Purpose and Scope

The purpose of this document is to provide answers to some frequently asked questions about the Energex Distribution Earthing Standard.

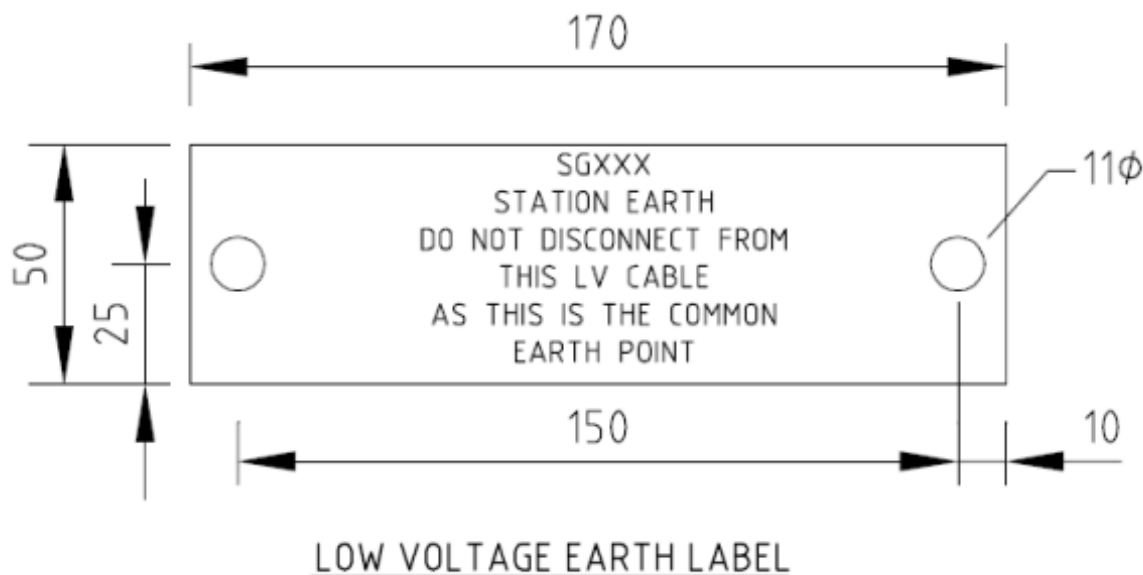
1. A new padmount transformer has been installed with the CMEN earthing arrangement, but without an earth tie interconnection to another transformer in the area. The conduits and the pits in between the two transformers have already been installed.

Would it be acceptable to install an earth cable through the existing conduits?

Yes, it is acceptable. A 70 mm² bare earth cable earthed at 100 m intervals (if permissible) is required to connect back to other transformers in the area where the CMEN system of earthing is used. Where earthing at 100 m interval is not possible, longer runs are permissible so long as the standard CMEN requirement can be met i.e., the connected earth resistance is not to exceed 1 ohm and disconnected local earths are not to exceed 10 ohms. LV earth label should also be installed at bond ends as according to The Standard for Network Labelling & Signage, drawing 7784-A4 B (shown below).
